Waterfront – Main Corridor North of Union St

Meeting Summary

Schematic Design

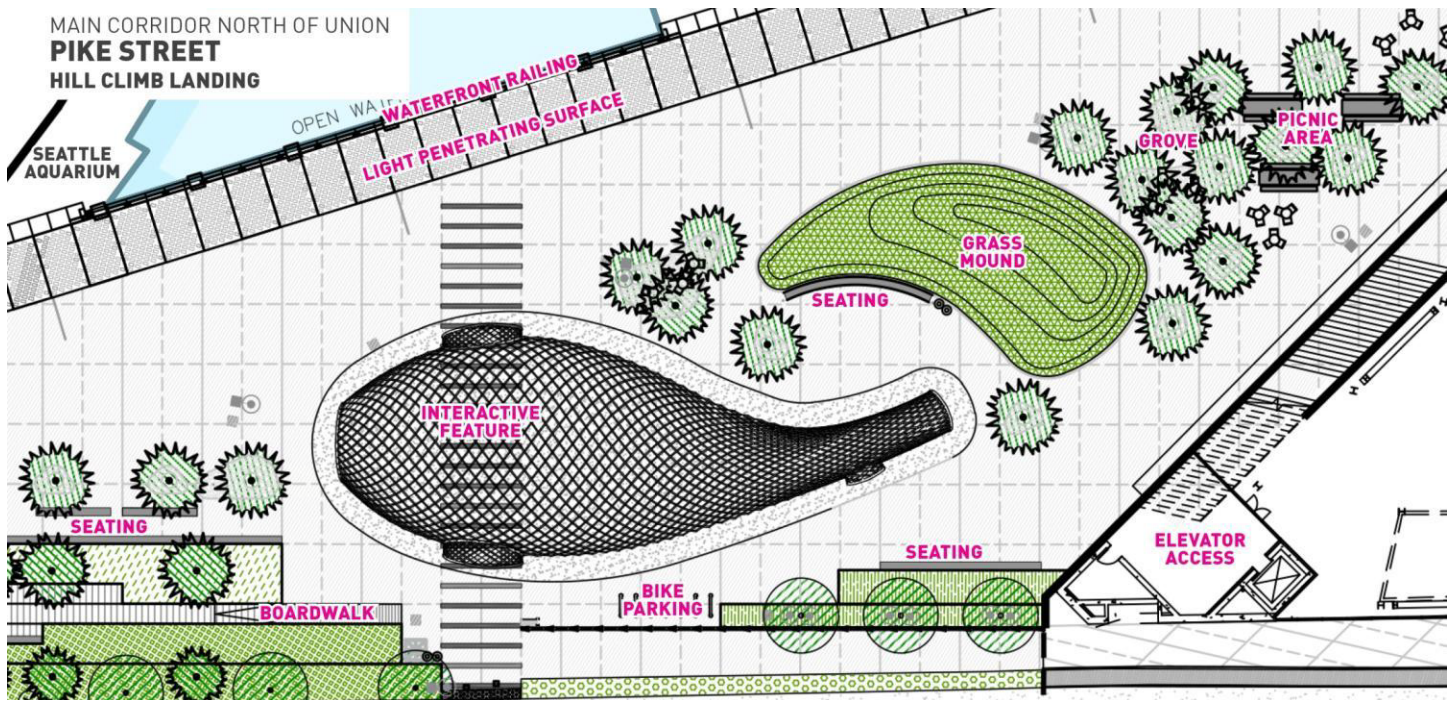
3. Explore additional opportunities to integrate salvaged material into the design as you have with the promenade handrails.
4. Study the number and placement of objects in Aquarium Plaza (below). Give more space around them rather than crowding this zone. Consider transitioning these objects into one another as you have successfully with paving treatments.

5. There is some uncertainty among the Commission about the fish sculpture (right) and a desire to understand its form and design in more detail. Do not let the fish sculpture preclude the opportunity for art to be fully integrated into the design for Pier 62/63 and the Central Public Open Space.

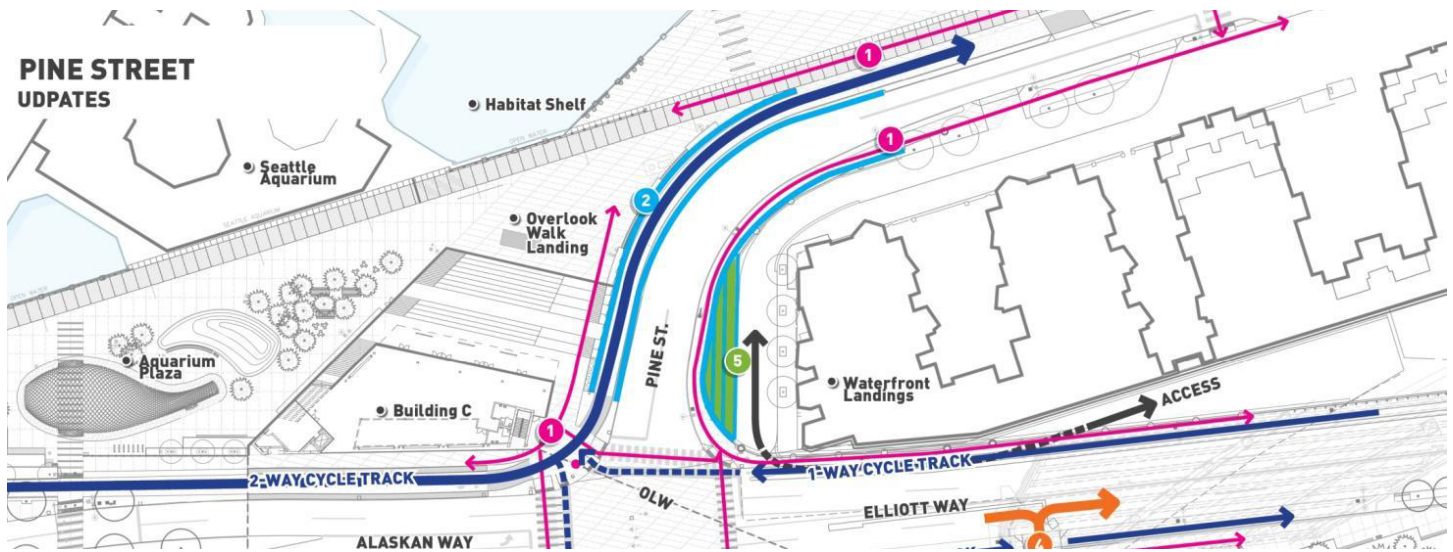
8. On Pine St, show more detail about how the cycle track and retaining walls transition at Alaskan Way near the light penetrating surface functionally, materially, and formally (below). The separation of cars and bicycles on Pine St feels strong and improved in section and elevation. The Commission appreciates that the project team has considered Waterfront Landings in the proposed design.

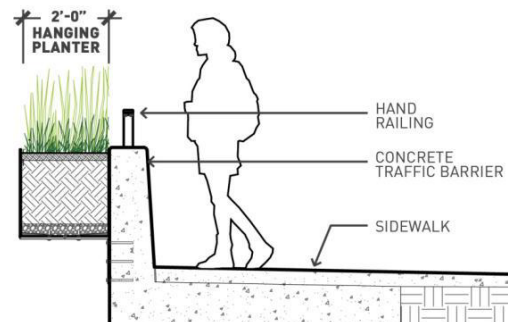
9. The one-way cycle tracks on Elliott Way are an improvement over the previous configuration. Take care when detailing important elements like the planter boxes along the edge of Elliott Way (below right) so they do not become marginalized or prone to collecting trash.
10. Be diligent in choosing, evaluating, and prototyping materials and coatings for durability and effect.
11. While the Commission recognizes the uncertainty about the future of the Lenora Street Bridge, the existing plantings are valuable given their scale and should be retained if at all possible.
12. Continue to develop direct, usable connections at Blanchard St, which has improved significantly from concept design (below). The potential development parcel could be an opportunity to serve latent community needs and might be less valuable as open space given the nearby portal site at Battery St.
